Barina Quarry Modification 3 (DA 1-01-2001-Mod-3)

Submissions Report

December 2025

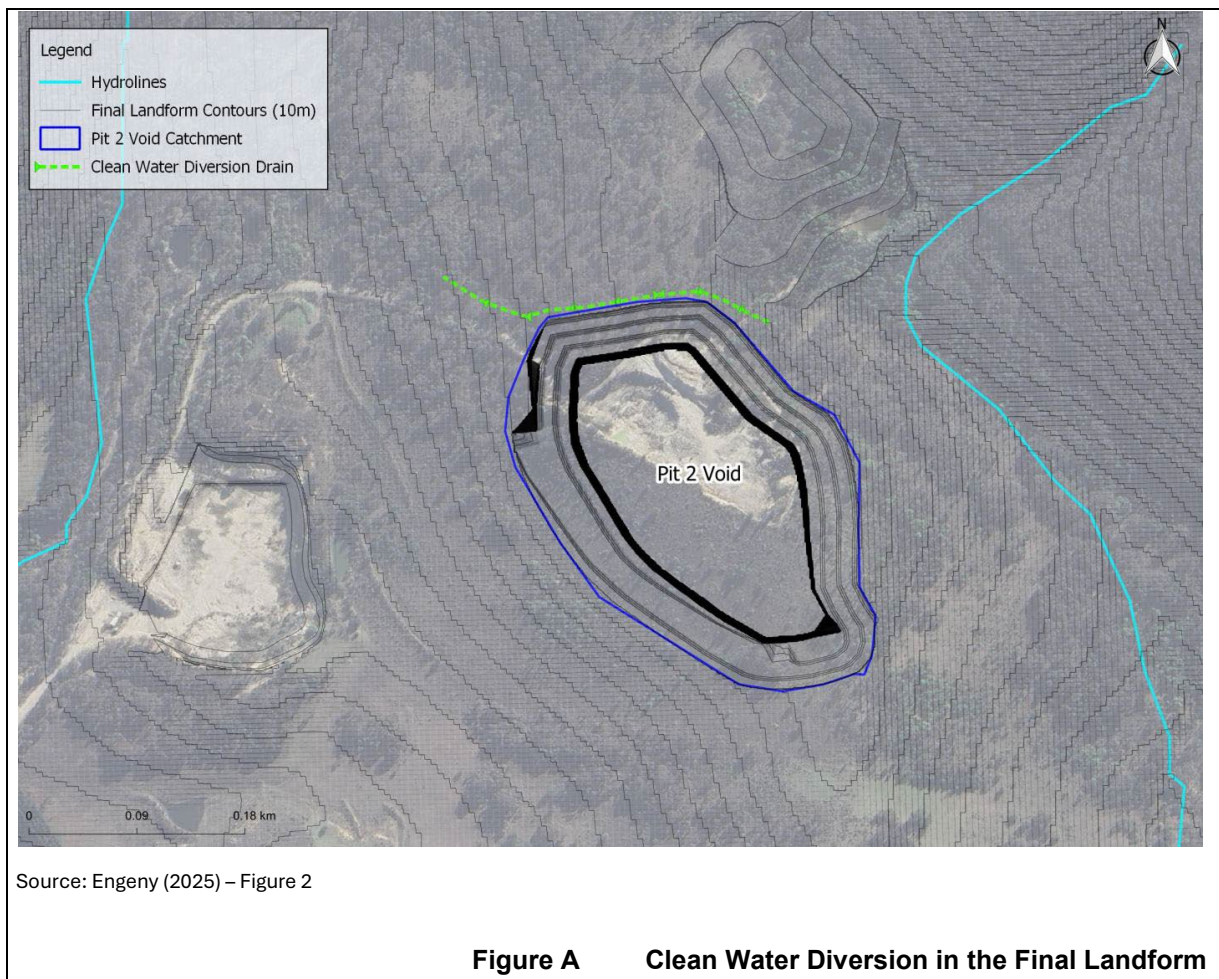
- Provide clarification of the potential for a pit lake to develop in Pit 2 void. Whilst groundwater is not predicted to be intercepted, the surface water assessment does not provide enough information on the surface water flows. In particular, whether water management infrastructure such as diversion drains are required in the final landform to prevent inundation (both short and long term) of the Pit 2 void and how this would impact the proposed final land use of grazing.

Engeny Pty Ltd was engaged to update the Water Balance Model for the Quarry operations to consider the potential accumulation of water within the Pit 2 void. The results of the updated WBM is included as **Item 6** in a consolidated letter report of Engeny which is included in full as **Appendix 7**.
